Access Compliance Report Public Rights-of-Way (Curb Ramps)

Main Street: O_NEILL_DR		Cross Street: ETON_PL		Location:	N
ADA ID: RPRK211027121437	Ramp Type: Type 6 - Directional 1	Initial Pass/Fail: Fail	Overall Compliance: No	Severity Score:	2
Codes/Mitigation Info/Possible Solution			Field Measurements/Component Compliance

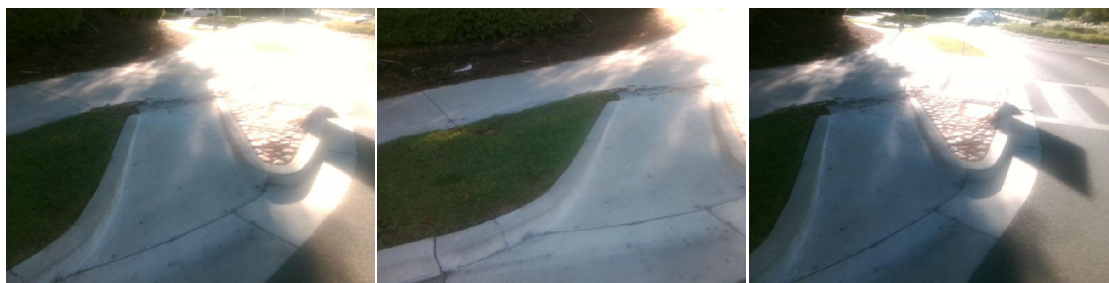
R204.3, R304.5.3, STD 1115

Remove & Replace Entire Ramp.
